KM Nobely Garments Ltd.

21st December 2020

Structural Inspection Report

Observations & Actions

Concrete strength test report

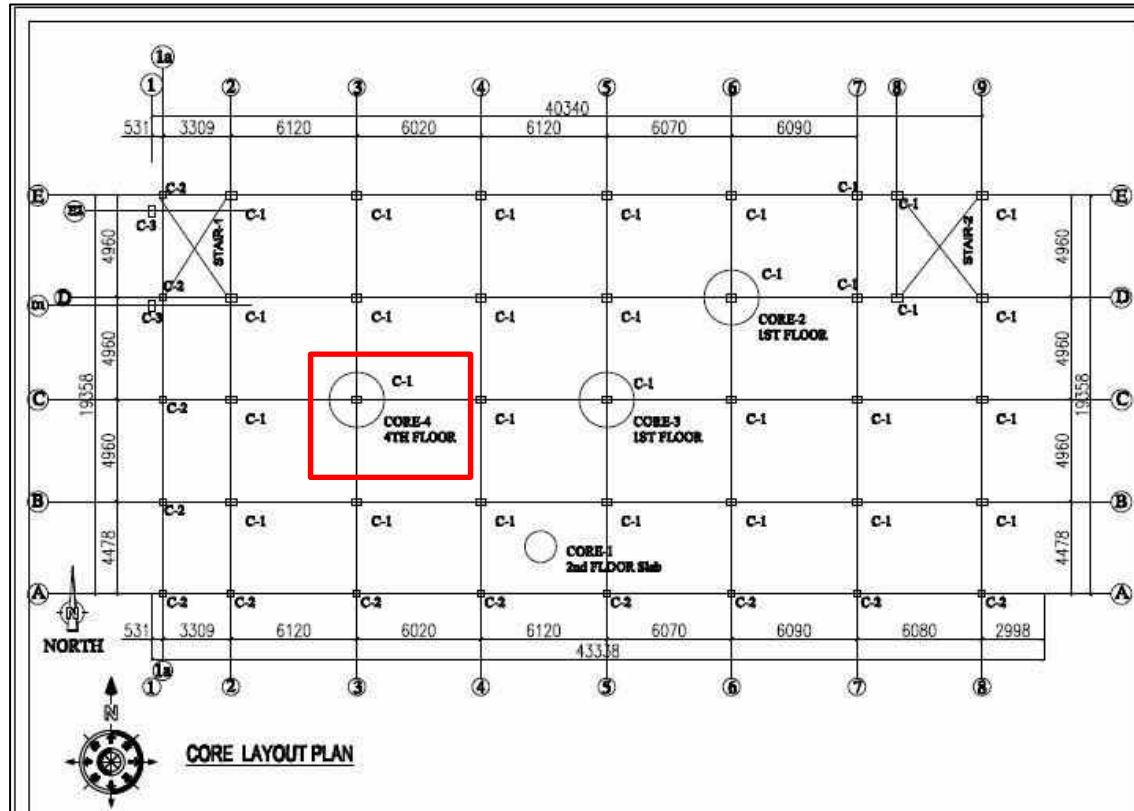
Total four number of concrete core samples are taken, three samples taken from column & one sample taken from slab. As per core layout plan one core sample was taken from the 4th floor column which is actually constructed for encasing the steel column for fire protection. Factory engineer is required to take minimum number of core samples from columns to evaluate concrete strength.

- Building Engineer to prepare design report as per BNBC (part-6; Article 1.9.1) by reviewing design, loads and capacity of structural members.
- Verify in situ concrete strength by taken 100 mm diameter cores (minimum 4 nos.) from lower tier columns.
- Building engineer is required to check the connection type & requirement of any additional features.

Detailed Engineering Assessment Report

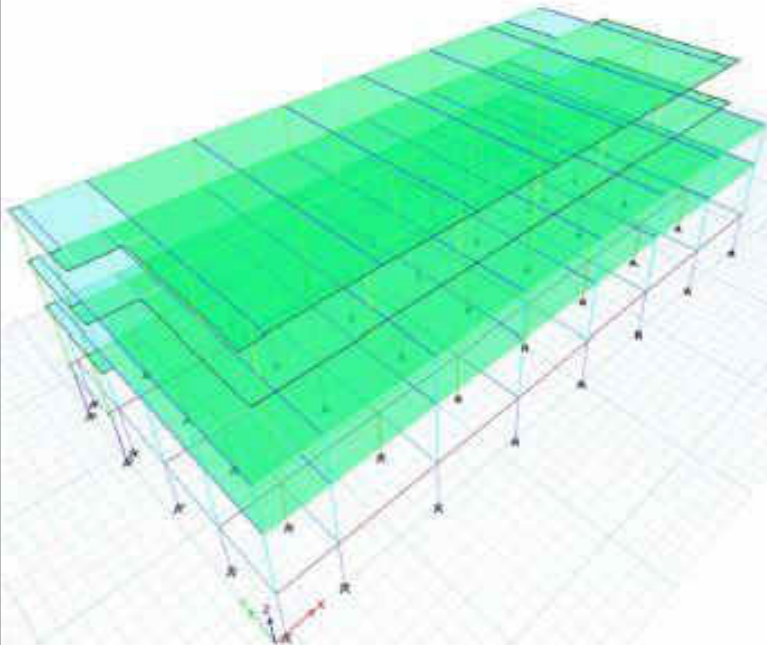
Allowable bearing capacity considered in the design report does not match with the recommendation of geotechnical investigation report. No calculation is provided regarding the considered value.

As per BNBC every building or structure designed shall have its design documents prepared in accordance with the provision of Section 1.9.1. The design document shall include a design report, and a set of structural drawings, which shall be prepared in compliance with section 1.9.1.1 and section 1.9.1.2 as per BNBC. During the inspection, the prepared design report has not compliance with section 1.9.1.1(part-6, BNBC) which is mentioned in previous slide.

**Apparently inadequate connection of steel cladding.
(Production Building)**

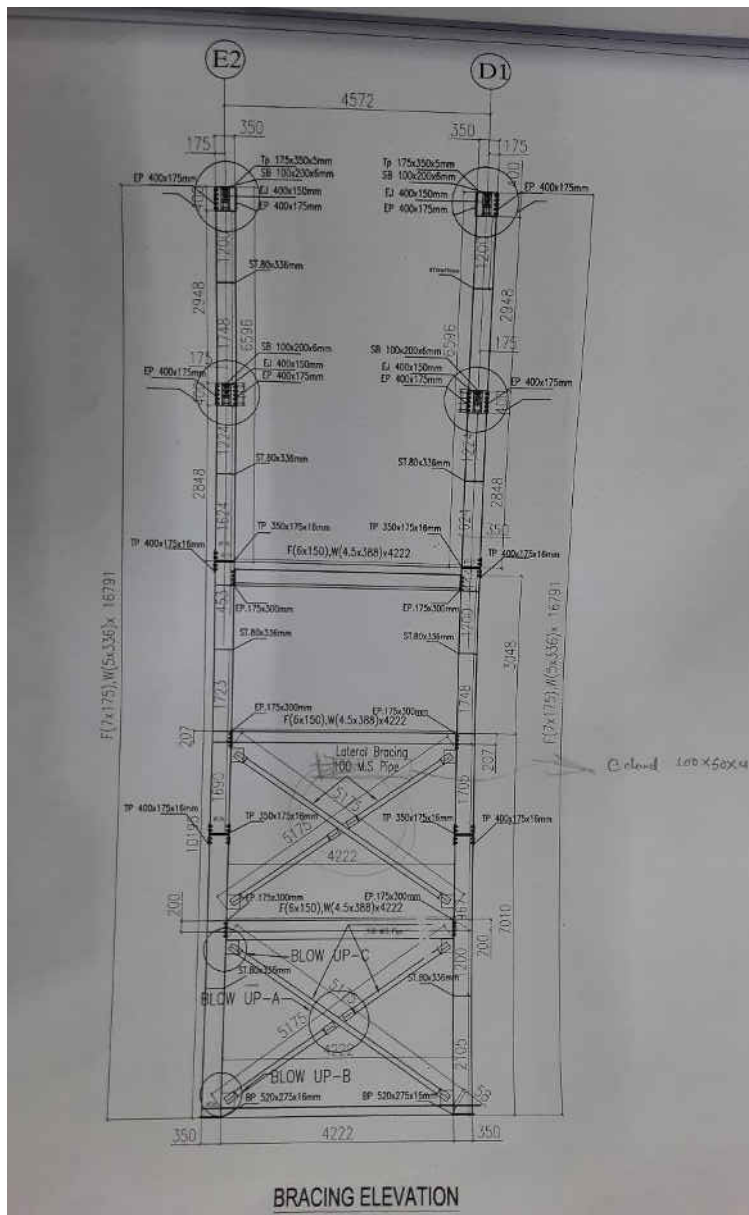
Apparently poor connection in the steel cladding system. Building engineer is required to check the connection adequacy against the wind loading.

- Building engineer is required to check the connection adequacy against the wind loading.

Bracing elevation on drawing

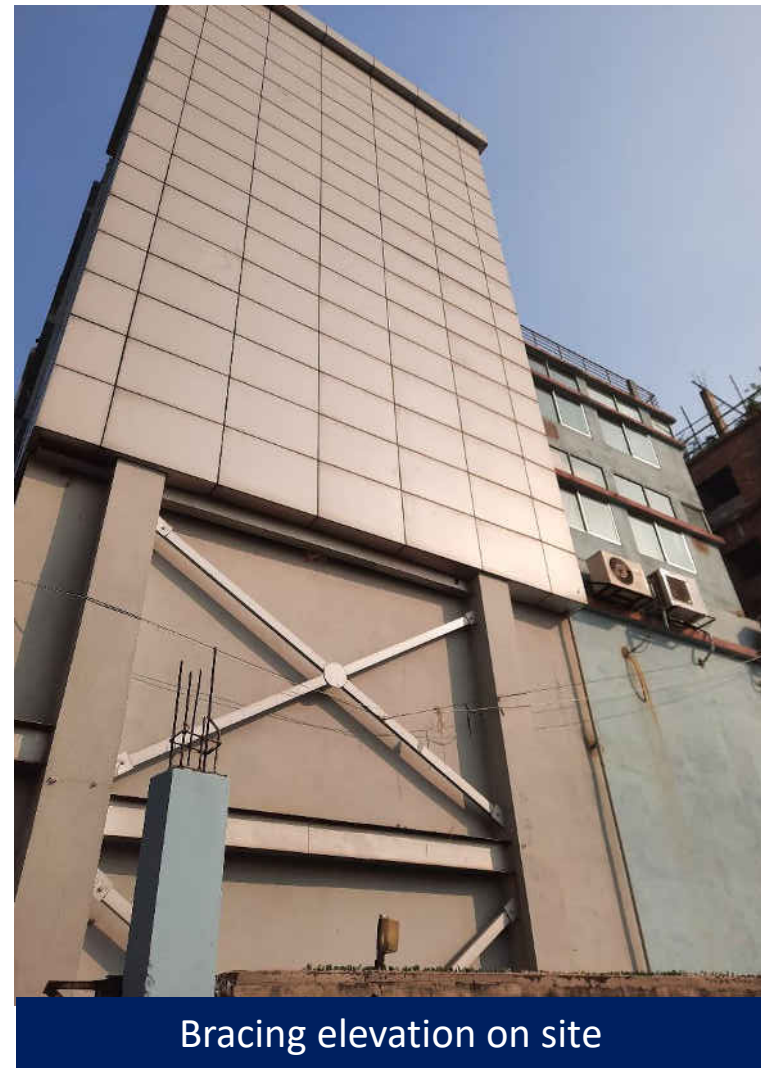
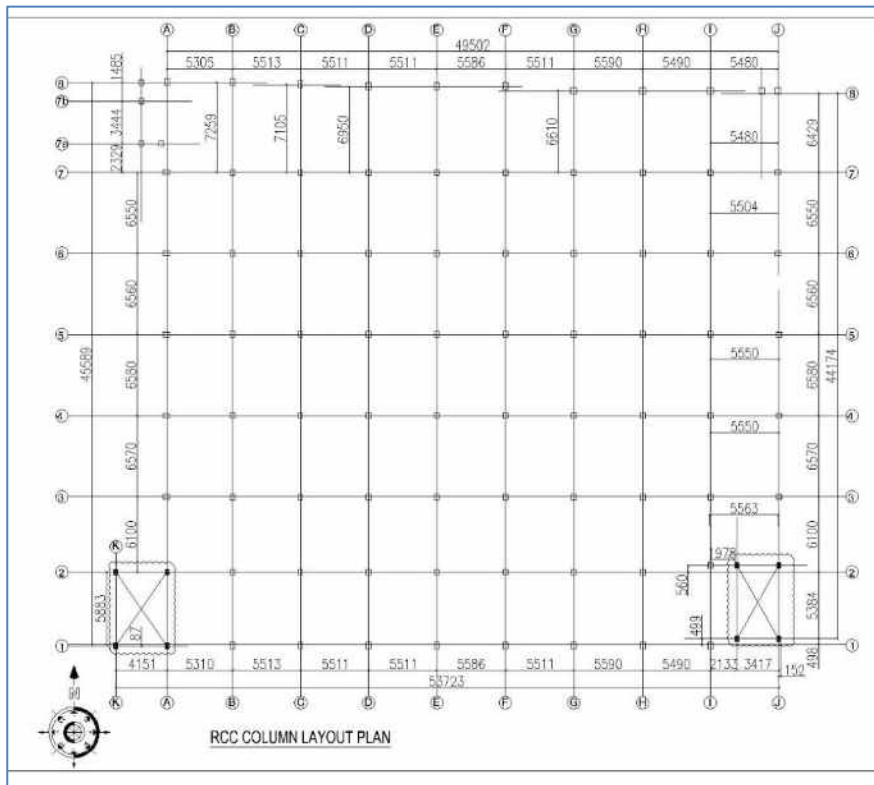
100 mm diameter pipe bracing shown on drawing, onsite C channel of 100 mm X 50 mm X 4 mm bracing was found.

- Building engineer is required to survey the both structures and prepared as constructed drawings.

RC column layout plan

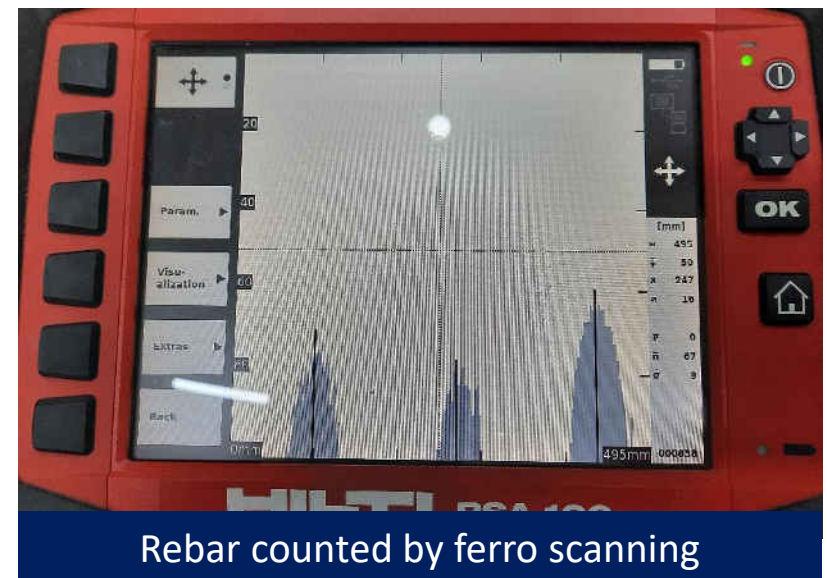
As-built drawing shows 12 number of rebars in the C5 column. But on site 8 number of rebars were counted by ferro scanning.
